City Park Development at the Former Tedcastles Site

Quality Audit

Reference: 267365-ARUP-XX-XX-RP-YT-0015

Quality Audit

2.1 Problem: Visibility Splays at Accesses

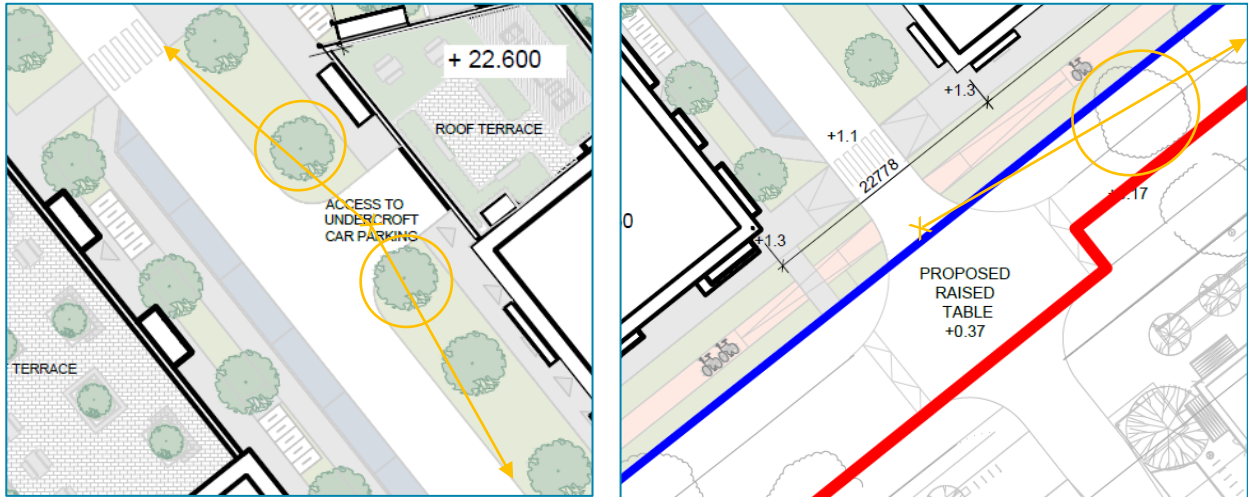
It is not clear from the drawings if the required sight distances can be achieved for motorists exiting the Block C carpark entrance or at the proposed access to Centre Park Road. Failure to achieve the necessary sight distances could lead to an increased risk of collision at the entrances.

Designers Response: Yes | Yes

The required sight lines should be achieved in accordance with DMURS at all new entrances.

2.2 Problem: Turning Area

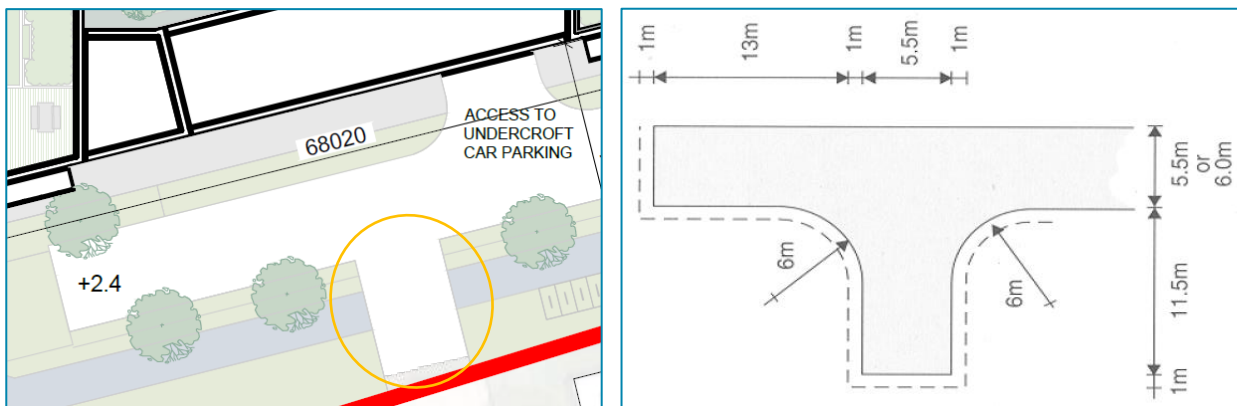
It is proposed to provide a turning area at the end of the cul-de-sac access. The square corners of the turning area may make it difficult for larger vehicles especially service or delivery vehicles to turn around and excessive manoeuvring may endanger other road users. Also, it is not safe for pedestrians to cross the turning area through the middle of the stem where vehicles reverse into.

Designers Response: Yes | Partially | The turning area has corner radii applied. It will also be part of a raised table area which will facilitate pedestrian crossings at grade at the top of the stem (it is not possible to divert the footpath around the turning area).

The shape of turning area should be revised to one closer to that shown in the right image above. The footpath should be realigned to the back of the turning area.

2.3 Problem: Priority and Intervisibility at Carpark Entrances

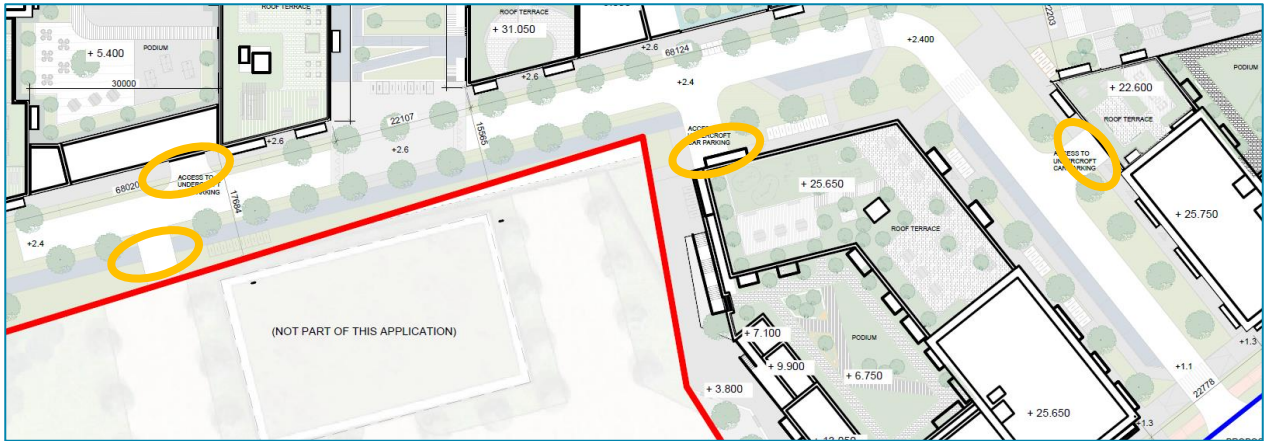
It appears from the drawings that motorists have priority over pedestrians at all private entrances. There is a risk that a pedestrian, who would normally have priority in this situation and in this type of neighbourhood development, would walk out in front of an emerging vehicle which could lead to a vehicle striking a pedestrian. The problem is made worse by the poor intervisibility offered due to the carpark entrances aligned with the front wall and the back of footpath.

Designers Response: Yes | Yes – partially | All pedestrian crossings are to be raised. The provision of bollards to direct pedestrian movement will be considered at detailed design stage.

A raised footpath should be maintained across all private entrances indicating that pedestrians have priority. Consider using a different paving pattern or shading at the footpath across the entrance/exit to indicate a shared use surface and increase awareness. Consider moving pedestrians out from the building at each of the carpark entrances by installing a vertical bollard on each side of the access close to the wall.

2.4 Problem: Shared Surface Street

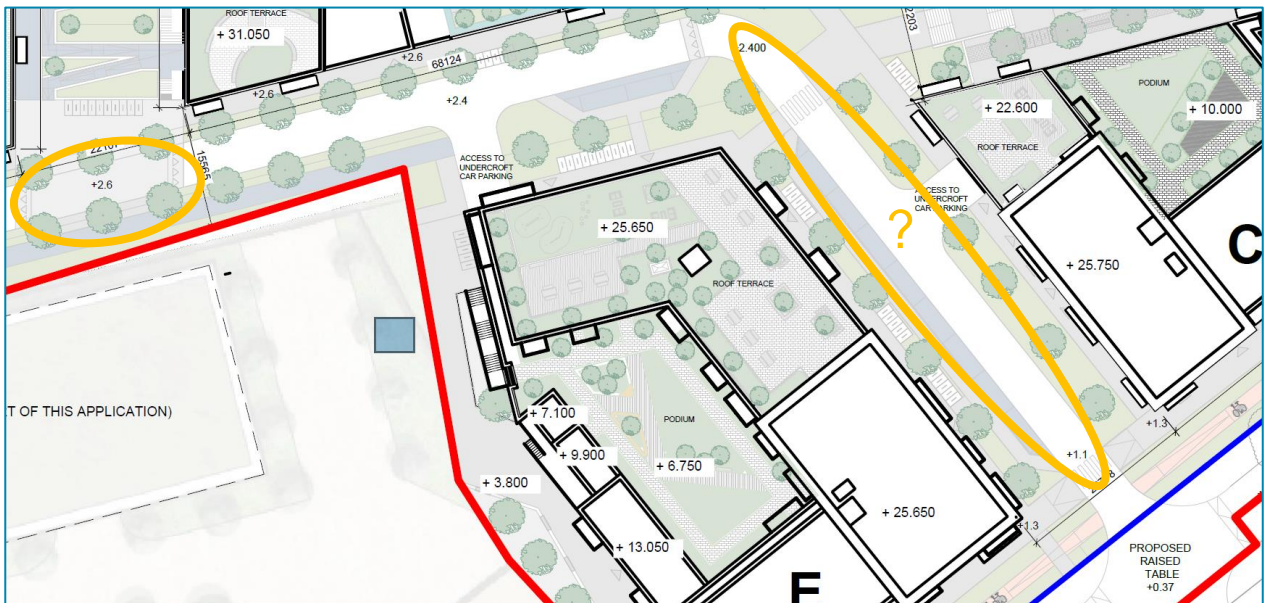
It is not clear from the drawing if it is proposed to have a shared surface street. Shared surface street would be appropriate for this type of neighbourhood development and are particularly effective at calming traffic and perform well in terms of road safety. However, if not designed properly, shared surface streets can be intimidating for impaired users. Failure to provide visually-impaired users with kerb lines to navigate streets could increase the risk of a collision with a passing vehicle.

Designers Response: No | No | To confirm, the internal street is not intended to function as a shared street

- Use a variety of materials and finishes that indicate that the carriageway is an extension of the pedestrian domain;
- Use sections of tactile paving that direct movement along the street or across spaces;
- Create distinct zones that delineate pedestrian only space from shared space;
- Include flush kerbs, drainage lines and/or sections of tactile paving to assist guide dogs and indicate movement from a pedestrian only space to a shared carriageway; and
- Proposed hardscaped verges that act as refuge zones allowing pedestrians to step on and off the carriageway to let cars pass.

2.5 Problem: Priority at Shared Surfaces

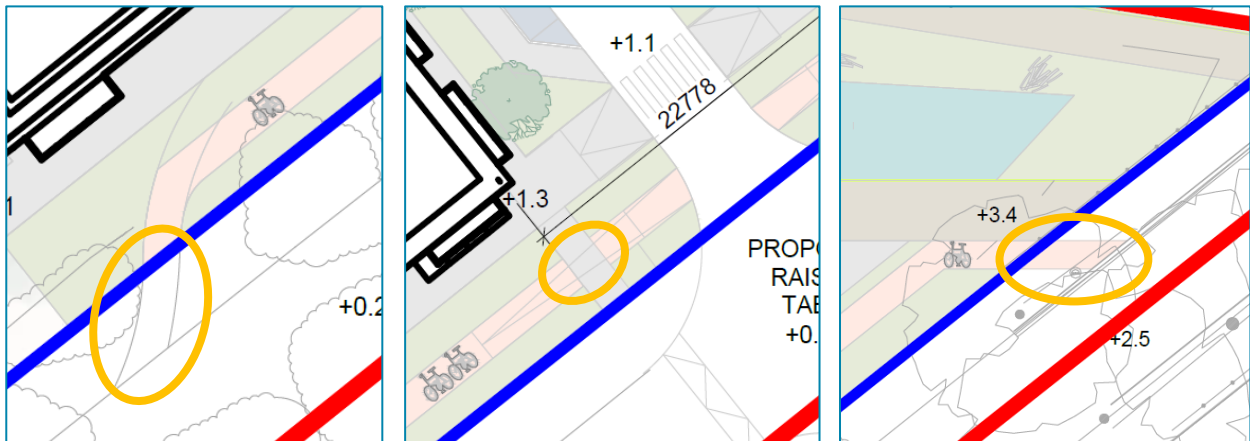
It is not clear from the drawing as to how it is proposed to introduce the shared areas between pedestrians and cyclists. Failure to convey who has priority at the shared areas increases the risk of a collision between a pedestrian and a cyclist.

Designers Response: Yes | Yes

Prescribe the necessary road markings and warning paving such as tactile paving or corduroy paving.

2.6 Problem: Exposed Water Edge

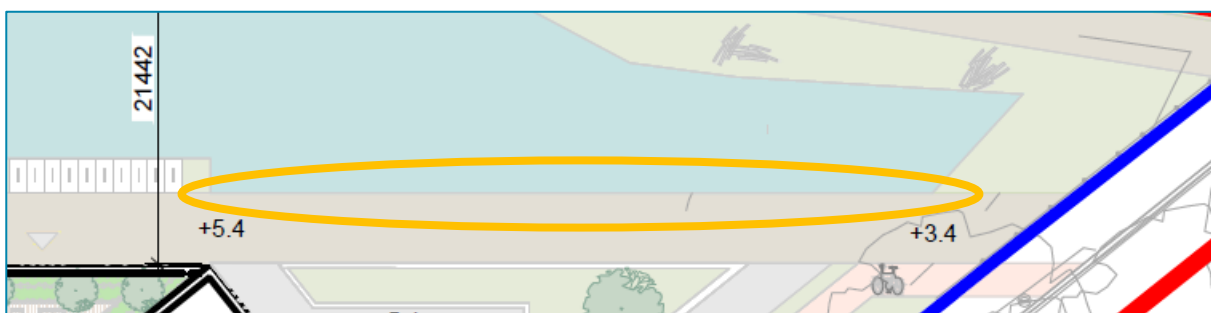
It is not clear from the drawing if it is proposed to install additional protection along the exposed water edge. The change in land use to residential, commercial and more social use will generate new and once off visitor trips who may not be familiar to this danger especially at night. There is a risk that a pedestrian or a child could fall into water.

Designers Response: Yes | Yes | A protective railing is proposed, and the area will be well lit.

Adequate protection should be provided along the walkway. Ensure lifebuoys are provided. Ensure that the walkway is well lit at night.

2.7 Problem: Pedestrian Crossing Width

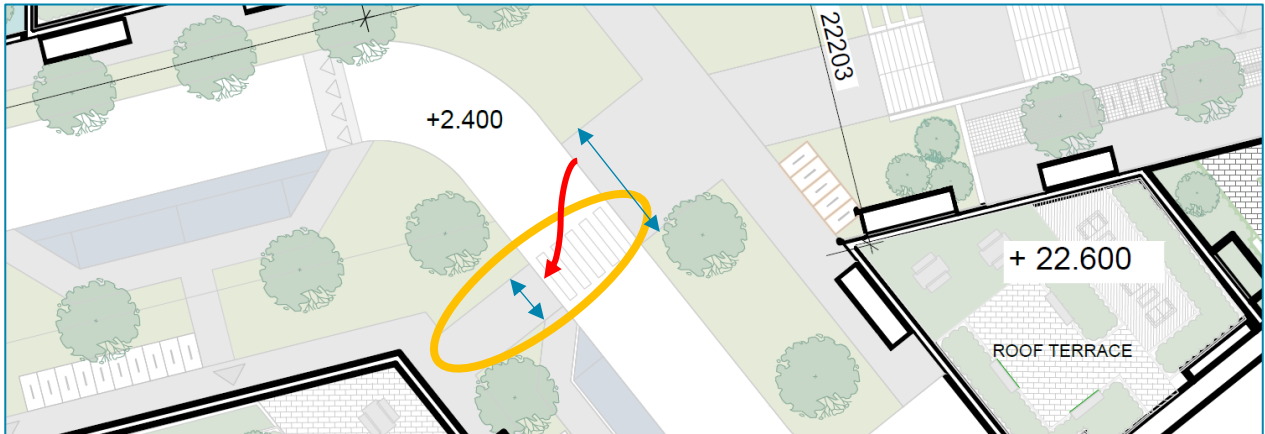
The pedestrian approach to the pedestrian crossing from the north is wider than the pedestrian crossing itself which may result in pedestrians walking in front of an oncoming vehicle or needing to walk for longer on the carriageway due to the grass landing area on the opposite side.

Designers Response: Yes | Yes | Crossing width has been amended

The width of the pedestrian crossing should be at least 4.0m and matches the width of its approaches.

2.8 Problem: Street Parking Footpath Surrounds

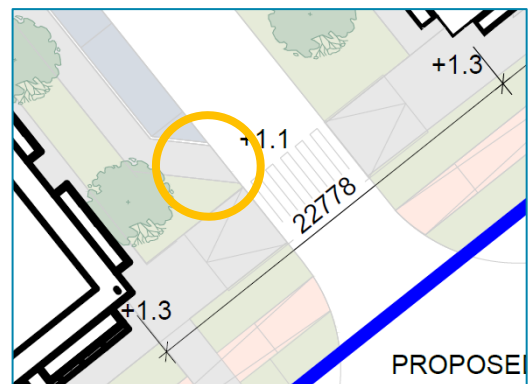
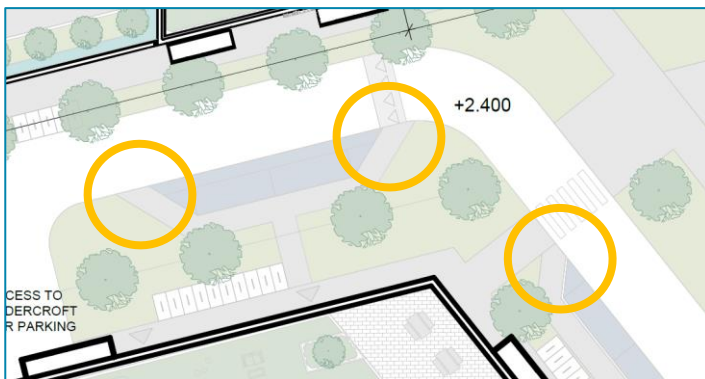
The paving at the end of both street parking areas lead pedestrians to walk directly onto the carriageway which may result in pedestrians walking in front of an oncoming vehicle or needing to walk for longer on the carriageway due to the grass landing on the opposite side.

Designers Response: Yes | Partially | The footpath areas will be connected to the wider footpath network.

Either remove the sections of footpath at the ends of the street parking areas or tie them into the footpath network or provide a formal pedestrian crossing when the footpath meets the carriageway.

2.9 Problem: Lack of Public Road Crossings

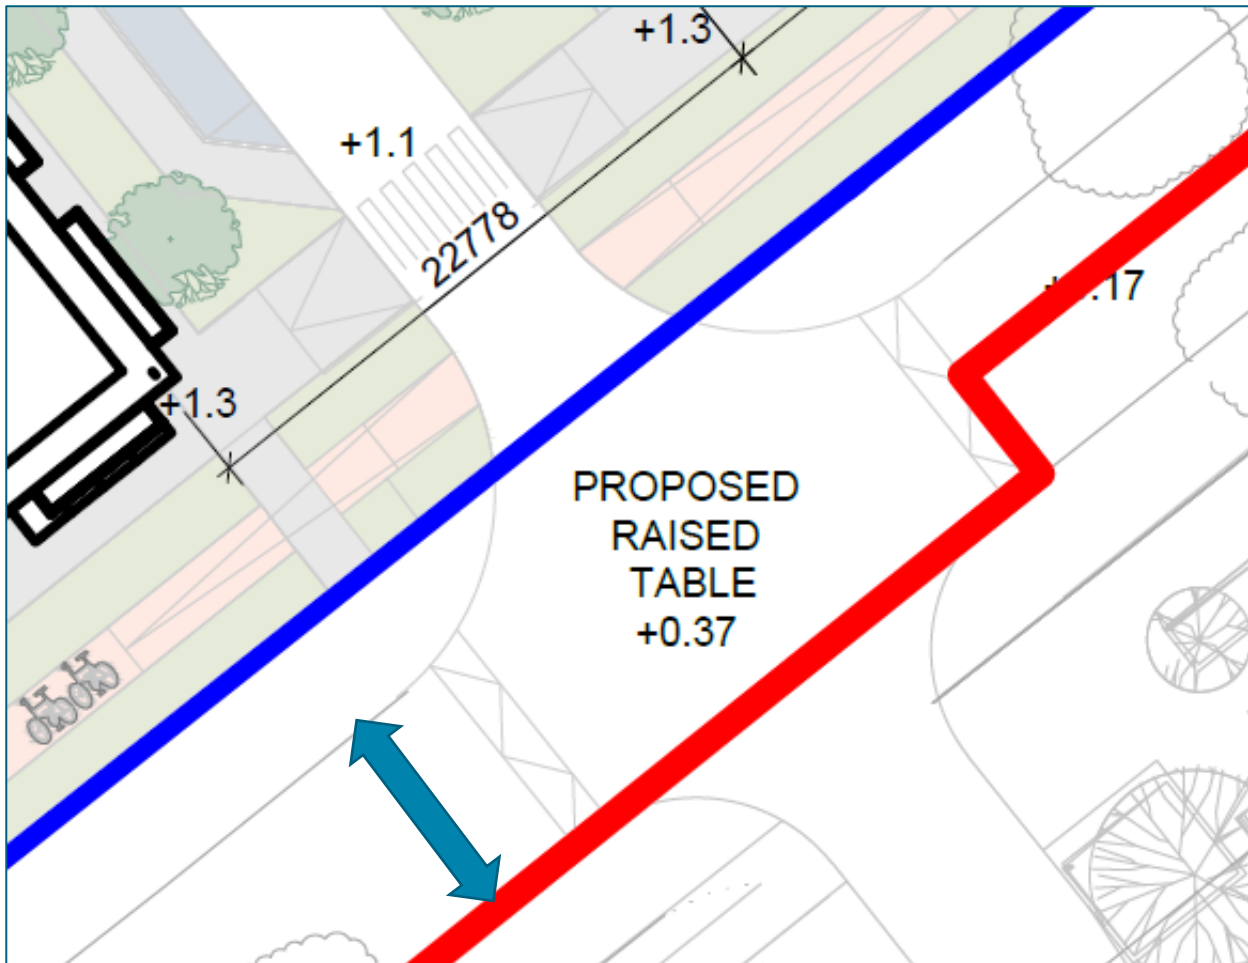
The proposed scheme does not appear to include any dedicated pedestrian/cyclist crossing facilities across the public road bounding the site. The proposed development will generate a considerable increase in pedestrian and cycling activity and there is a risk that pedestrians or cyclists will cross at random unsafe locations with an increased risk of been struck by a passing or turning vehicle. This risk is particularly high for pedestrians with a mobility or visual impairment.

Designers Response: Yes | No | There is no current pedestrian desire line across Centre Park Road at this location. However, once the adjoining site is developed and a pedestrian route available, the appropriate junction treatment and crossing facilities will be agreed with Cork City Council as part of future upgrades on Centre Park Road.

Appropriate pedestrian crossing points should be provided across Centre Park Road and follow pedestrian desire lines. Review the layout and examine the needs of pedestrians and cyclists in terms of new desire lines created by the development and its pedestrian and cyclist access points. All crossings and tie-ins should align with the proposals of other schemes and the existing facilities to ensure continuous and safe facilities.

2.10 Problem: Carpark Traffic Management

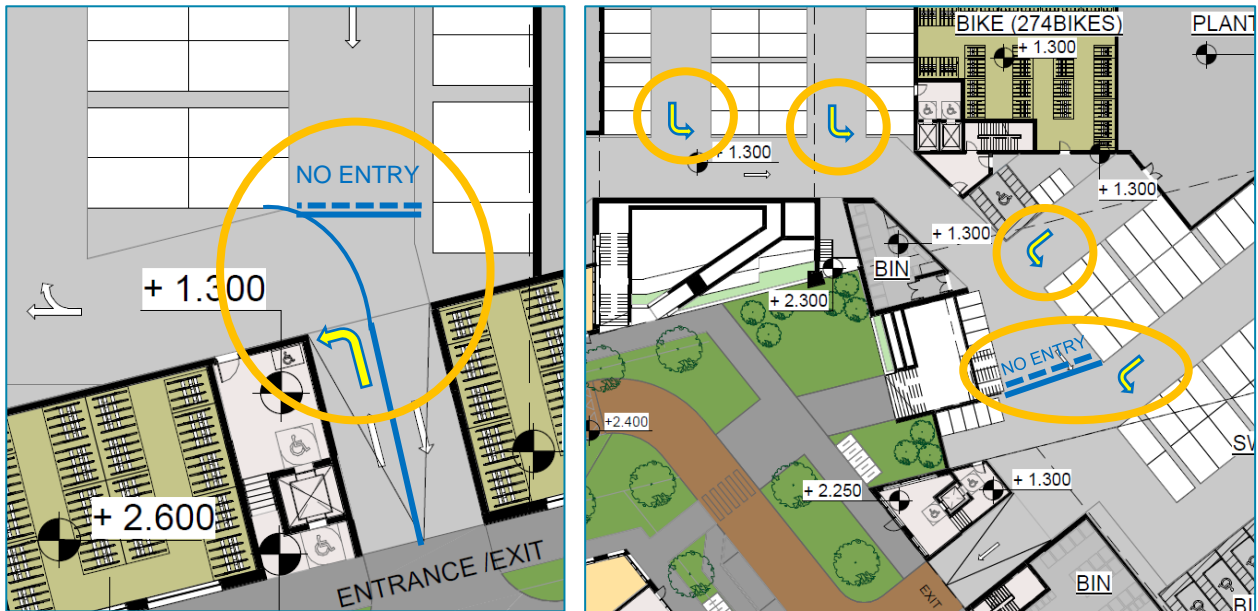
There is a danger that a motorist, unfamiliar with the carpark layout, entering the carpark may not appreciate the one-way system, especially if the white arrow road markings are obscured by an oncoming vehicle increasing the risk of a collision with an oncoming vehicle or a vehicle reversing out of the parking space.

Designers Response: Yes | Yes

Appropriate road markings should be provided. White arrow markings should be frequent and supplemented by other road markings such as a guidelines, text markings and signage to ensure one-way system is clear.

2.11 Problem: Long Carpark Aisle

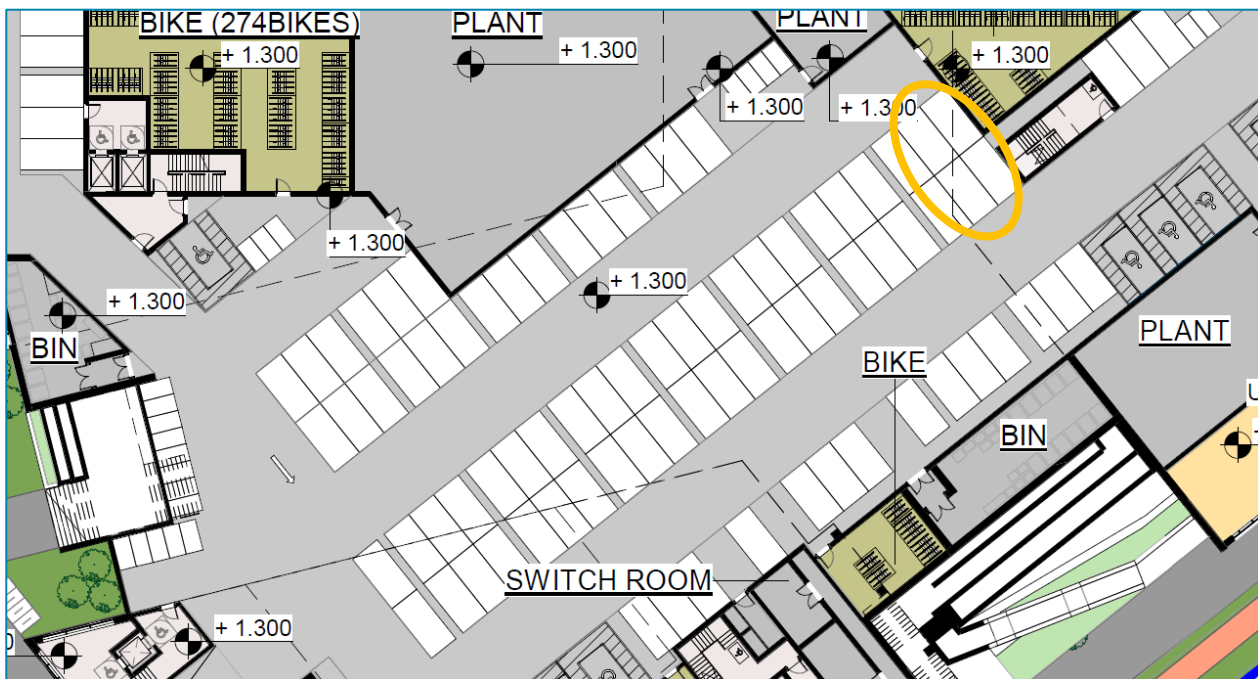
Motorists might not be able to see if there are any vacant spaces along a long aisle in the carpark which could lead to motorists requiring to turn around within the aisle and increase the risk of a collision with another vehicle or a pedestrian.

Designers Response: Yes | Yes | A suitable turning space will be provided for vehicles.

The last four spaces should be removed to provide a link between the two adjacent aisles allowing vehicle to circulate more freely.

2.12 Problem: End Parking Bays

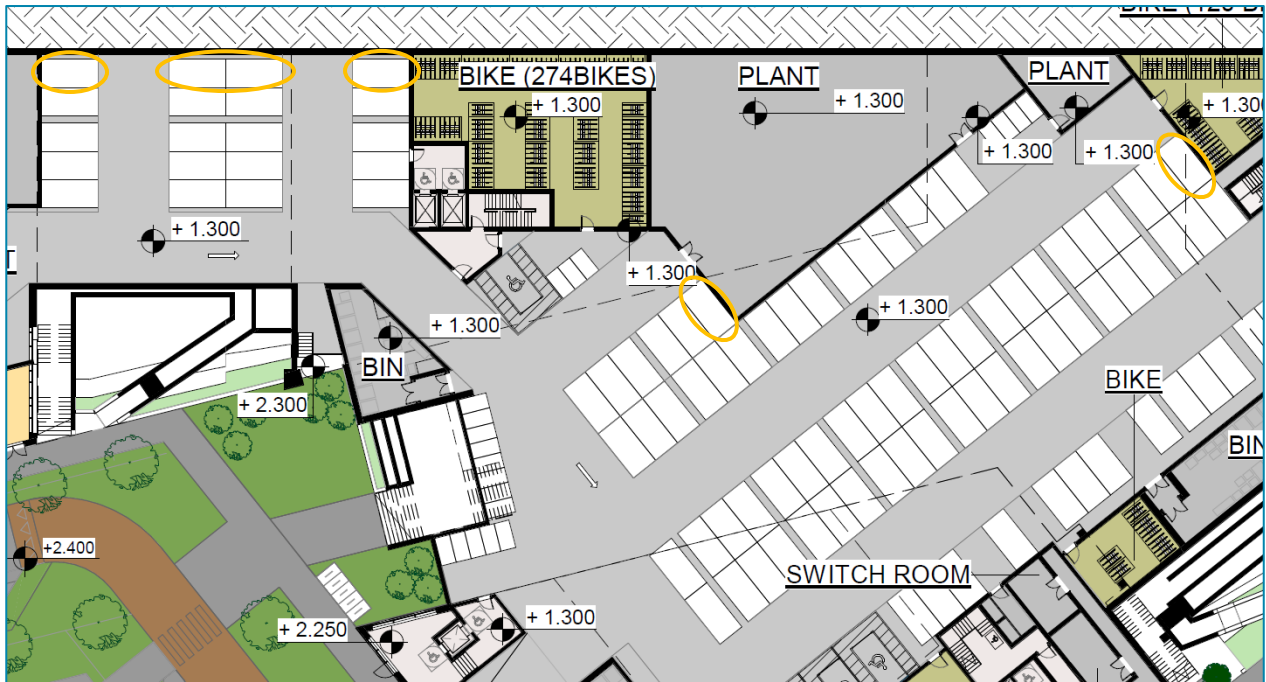
Many of the end parking bays may be difficult to use requiring multiple reversing movements increasing the risk of a collision with a pedestrian or another vehicle.

Designers Response: Yes | Yes

A vehicle sweep assessment should be carried out to ensure that motorists driving a large car can safely and easily use all end parking spaces when all of the adjacent spaces are occupied.

2.13 Problem: Doorways Obstructions

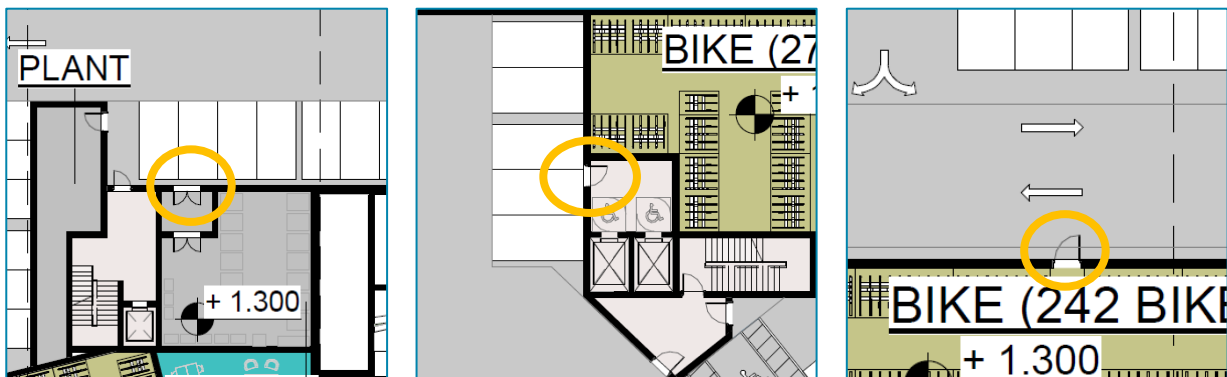
At a few locations, a parked car may block a doorway leading to the risk of trapping a person inside. Some doors appear to open out into the aisle where they could be struck by a passing vehicle.

All parking spaces should be kept clear of doorways and escape routes. Ensure that door cannot open in front of a car travel along the aisle.

2.14 Problem: No Advisory Carpark Pedestrian Routes

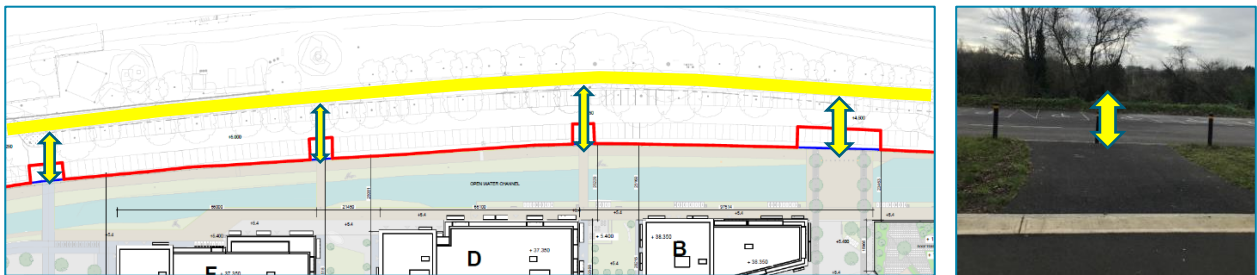
It is not proposed to provide any advisory lanes to guide pedestrians safely to the nearest exit. There is an increased risk of a pedestrian being struck by a vehicle within the carpark.

Provide road markings advising pedestrians of the safest areas to cross aisles and along with signage, the most direct and safest route to the exit points. If aisle widths are restrictive, then these need only to be advisory allow vehicles to drive on them if needs be.
